Product Change Notification

PCN20-23-JS Series Slide Switch Base Material Improvement

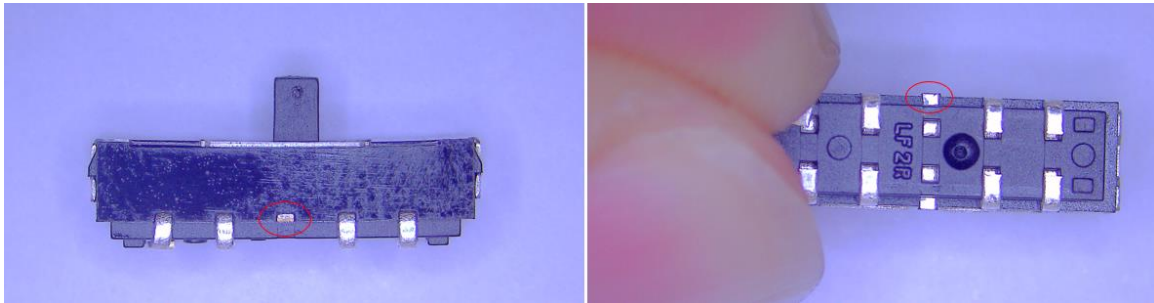
- 3.1 The base material plastic is changing from PA46 to PPA in order to leverage the lower water absorption of PPA as compared with PA46.
- 3.2 There is an associated cosmetic change in switch appearance as seen in the pictures below showing a trimmed off additional terminal in the middle of the switch base. This terminal is trimmed off such that it extends no more than 0.3mm outward from the switch base after trimming.
